National Transportation Safety Board

Safety Recommendation

Date: January 15, 1998

Figure 1. Aileron Wing Control Cable System.

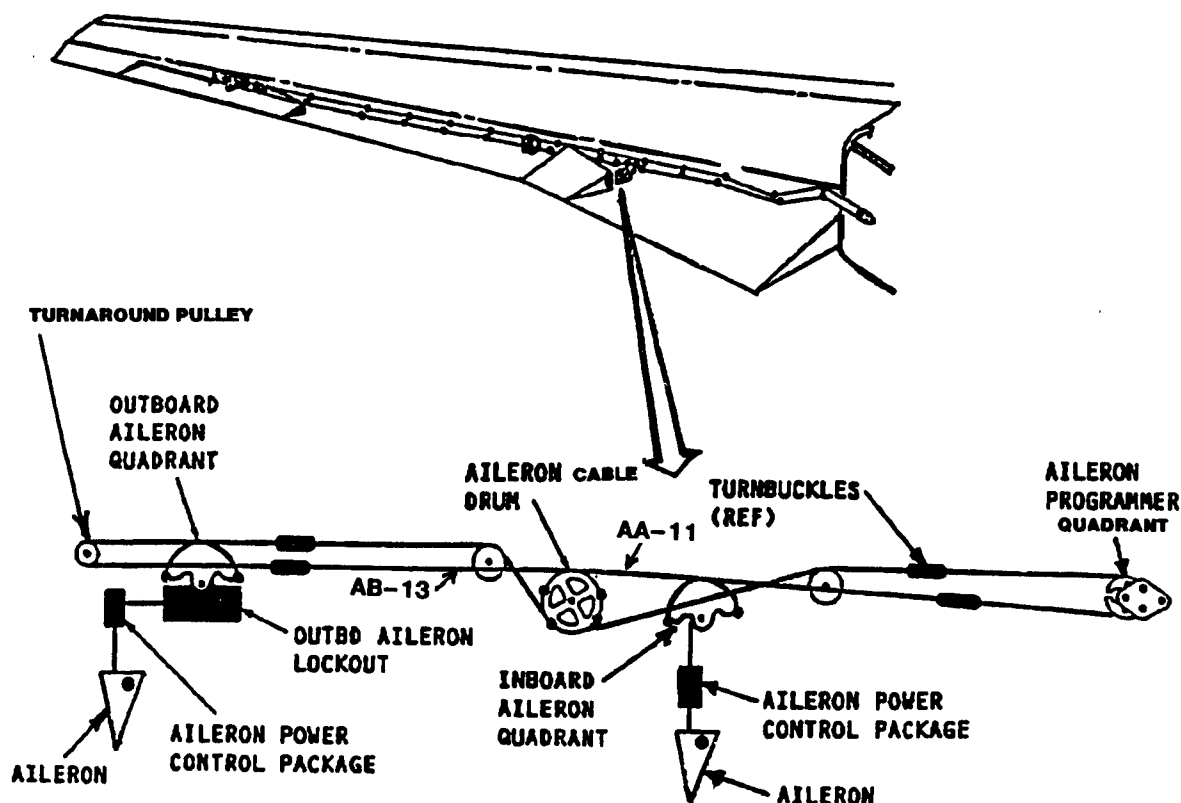
Further investigation by BASI revealed that the two aileron control cable decals¹ on the aileron cable drum's inboard and outboard mounting brackets at WS767 and WS780 were installed incorrectly. The decal for WS767 was fitted at WS780 and vice versa. BASI also found that a similar 747 aircraft, S/N 23028, production line number 584, had the aileron cable replaced because of excessive wear, and the cable was frayed down to one remaining strand. This aircraft also had the two aileron control cable decals on the aileron cable drum's inboard and outboard mounting brackets at WS767 and WS780 fitted incorrectly and interchanged. Because of the decals' transposition, the Safety Board requested a U.S. operator to randomly inspect its 747 airplane aileron control systems for the aileron cable drum decal identification at WS767 and WS780. An inspection on November 24, 1997, of one 747-251, S/N 21707, production line number 378, revealed similar decal transposition on the right WS767 and WS780.

According to Boeing, if these decals are interchanged during installation, the transposition results in incorrect cable routing information at the aileron cable drum and may lead to incorrect cable positioning during installation. A review of the applicable engineering drawings shows that instructions for the decal installations are correct. A check of undelivered 747s at the Boeing factory (production line number 1130 and onward) revealed correct decal installations.

The BASI investigation concluded that the Brisbane incident was caused by misrouting of cables on the aileron cable drum at WS776.98 and that transposition of the aileron control cable decals on the aileron cable drum at WS767 and WS780 has the potential to cause misalignment of the aileron control cables during installation. The Safety Board is concerned that airplanes with mispositioned aileron cable installation decals may be susceptible to aileron cable failures in flight, which could jeopardize flight safety. The Safety Board believes that the Federal Aviation Administration should issue an airworthiness directive to require operators of 747s, produced before production line number 1130, to conduct a one-time inspection of the aileron control system to ensure correct routing of aileron control cables on the aileron cable drum located at WS776.98 and correct installation of aileron cable decals at WS767 and WS780 at the earliest possible inspection interval.

Issue an airworthiness directive to require operators of Boeing 747 airplanes, produced before production line number 1130, to conduct a one-time inspection of the aileron control system to ensure correct routing of the aileron control cables on the aileron cable drum located at wing station (WS)776.98 and correct installation of aileron cable decals at WS767 and WS780 at the earliest possible inspection interval. (A-98-6)

Figure 1: Ruptured diffuser case

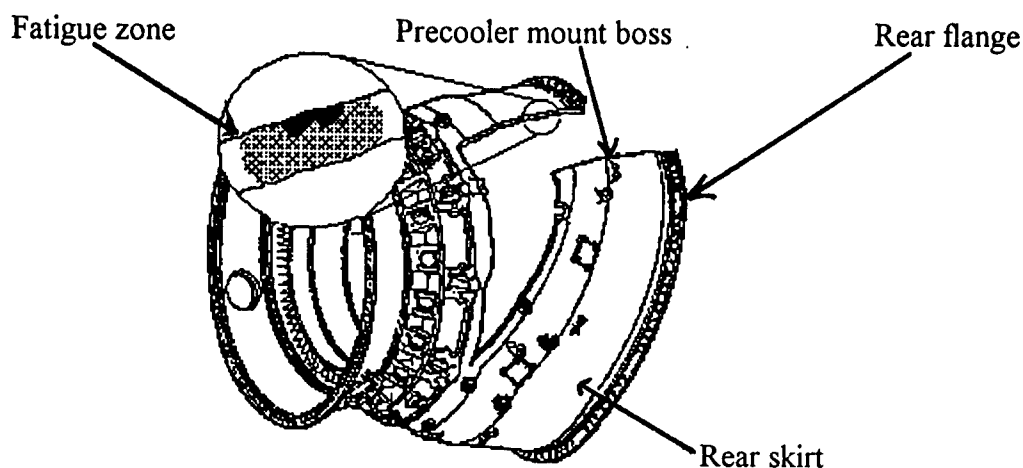
A section of the diffuser case rear skirt (see figure 1) was examined at the Safety Board's materials laboratory in Washington, D.C. Examination of the fracture surface, approximately 10 ½ inches from the rear flange, adjacent to the upper precoolers mount boss, revealed a 5-inch long discolored high cycle fatigue³ (HCF) zone with about 90,000 striations. The fatigue initiated at a crack that looked like two thumbnail-shaped, gray-colored areas, which were approximately 0.040-inch wide by 0.010-inch deep. High levels of delta phase precipitate⁴ were discovered in the thumbnail-shaped origin areas. Individual 0.0005 to 0.0008-inch deep toolmarks or scratches were found on the outer case wall extending the length of the origin area. Numerous additional toolmarks were found on the exterior surface of the rear skirt. The toolmarks were formed when the exterior surface of the case was machined (blended) during manufacture. The diffuser case had accumulated 9,342 total flight cycles⁵ since new.

A metallurgical analysis of the fracture surface indicated that the thumbnail-shaped cracks had initiated at the base of the toolmarks because of a combination of high residual stresses and low-cycle fatigue⁶ (LCF). The crack then propagated in HCF, as evidenced by the very small striation spacing found in the majority of the 5-inch long fatigue zone, after which the crack progressed to failure in tensile overload.

Because it appears that preventative measures can obviate future diffuser case ruptures originating in the rear skirt area with minimal impact to airline operations, the Safety Board believes that the Federal Aviation Administration (FAA) should require a one-time visual inspection of the diffuser case rear skirt on P&W JT9D-7Q engines to locate scratches and tool marks when the diffuser case is next at the piece-part level, and blend repair as required to prevent tool marks and scratches from becoming crack initiation sites. The Safety Board also believes that the FAA should require modification of the engine bracket that attaches to the diffuser case's precooler upper mount boss on the P&W JT9D-7Q installation to increase clearance between the bracket and support link to reduce vibration and to reduce wear.

Require modification of the engine bracket that attaches to the diffuser case's precooler upper mount boss on the Pratt & Whitney JT9D-7Q installation to increase clearance between the bracket and support link to reduce vibration and to reduce wear. (A-98-26)

Figure 1 Containment Shield Configuration

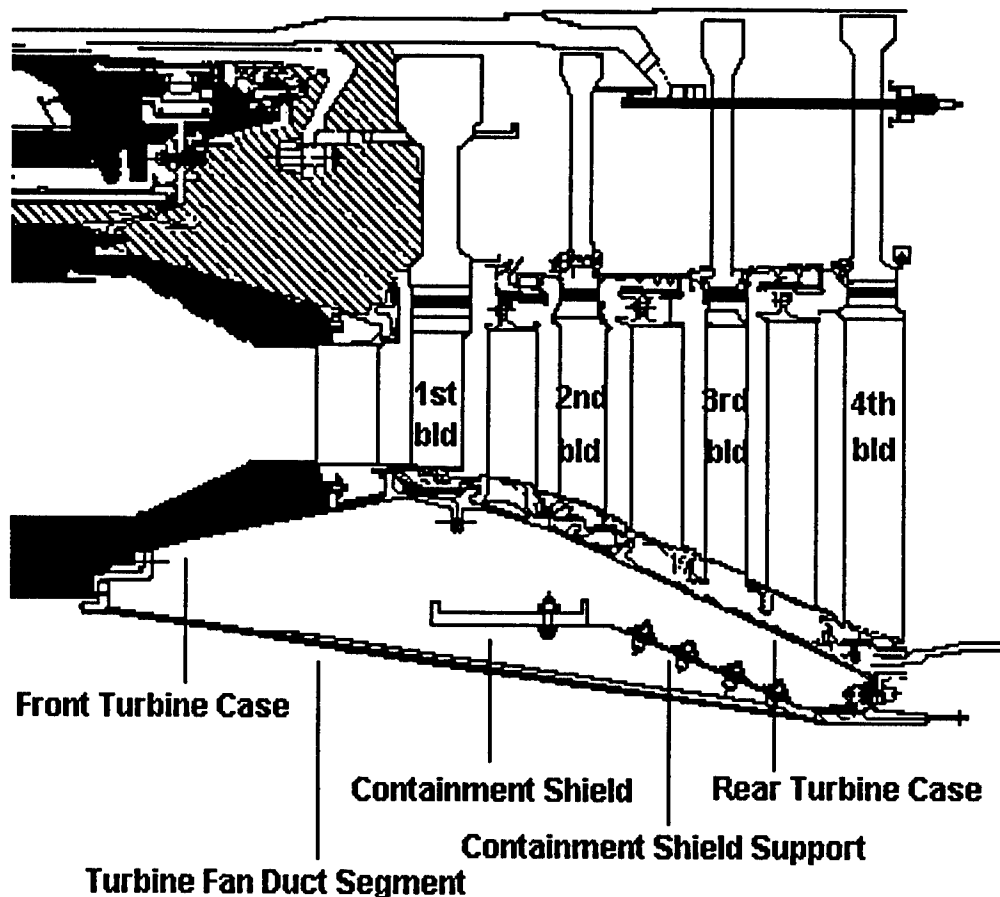
applicable to all JT8D-209, -217, -217A, -217C, and -219 turbofan engines. The containment shield is a clam shell design consisting of two half-shields joined by clevis plates and supported by a cantilevered shield support attached to the HPT rear flange. Considerable impact damage (engine debris) was observed on the inner diameter (ID) of the containment shield; however, the shield remained intact. The impact of turbine material on the lower shield shifted it outward and aft from its normal installed position, buckling its support. First-stage turbine blades and 2nd-stage turbine vanes had exited the engine through the openings between the HPT and LPT case flanges and deflected off the containment shield ID while exiting the engine and before striking the airframe.

Another incident involving a P&W JT8D-219 uncontained turbine failure that resulted from a sheared HPT shaft occurred on July 13, 1996, on a Centennial Airlines² McDonnell Douglas MD-80 airplane, en route from Dusseldorf, Germany, to the Canary Islands. Like the Reno Air incident, the failed engine was equipped with an HPT containment shield, which was not
